**Subject: Beaver Valley Power Station, Unit Nos. 1 and 2
BV-1 Docket No. 50-334, License No. DPR-66
BV-2 Docket No. 50-412, License No. NPF-73
Response to Request for Additional Information in Support of LAR
Nos. 327 and 197 Steam Generator Level Allowable Value Setpoints**

Request for Additional Information
Beaver Valley Power Station, Unit Nos. 1 and 2 (BVPS-1 and 2)
Steam Generator (SG) Level Allowable Value (AV) Setpoints,
NRC Method 3 Concerns

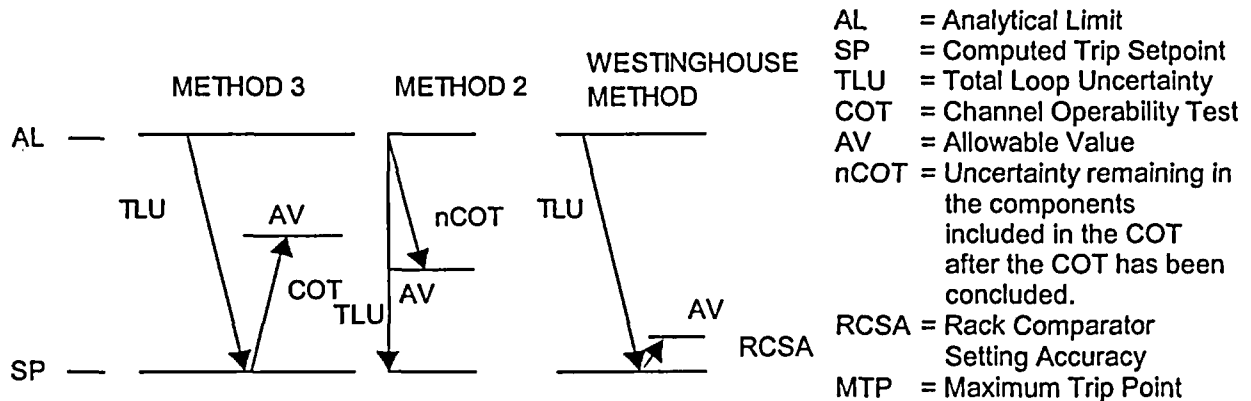
1. Discuss the setpoint methodology used at BVPS-1 and 2 to establish AVs associated with LSSS setpoints.

The methodology to determine the AVs for the BVPS-1 and BVPS-2 technical specification protection setpoints is not based on any of the methods as described in the ISA recommended practice document (ISA-RP67.04-1994, Part II or ISA-RP67.04.02-2000). The Westinghouse method used for the BVPS-1 and BVPS-2 technical specifications determines a performance based AV. As noted in WCAP-11419 Rev. 2, and WCAP-11366 Rev. 4, the AV is satisfied by verification that the channel "as-left" and "as-found" conditions about the nominal trip setpoint are within the Rack Comparator Setting Accuracy (RCSA). The AVs are used as the technical specification Limiting Safety System Setting (LSSS) values and are reflective of the RCSA value utilized in the CSA equation above. The Analytical Limit (AL), surrogate for the Safety Limit (SL) is protected by determining a Setpoint (SP) established on the conservative side of the AL such that the difference between the SP and AL will support the CSA, with some additional unassigned margin quantified in WCAP-11419 and WCAP-11366.

The following figure shows the relative relationships for a rising process and high limit.
